Technical Service Bulletin

Cobra Motorcycle Mfg.

TSB1407: ECX Radiator Mounting Brackets

May 31, 2007

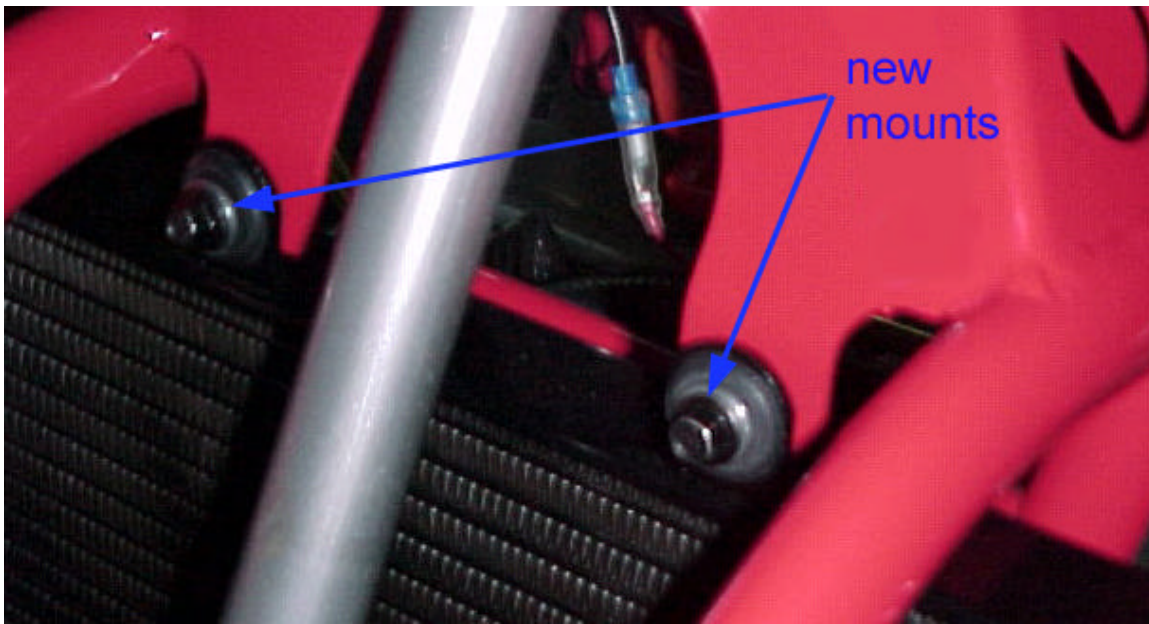
Cobra has changed the style of mounting brackets to help prolong the life of the radiators. Broken radiators will no longer be a warranty item with the release of this mounting arrangement.

The new hardware includes

2 bolts	HCBF0625
2 grommets	MCEXGR01
2 mount bushing	TCHA0006
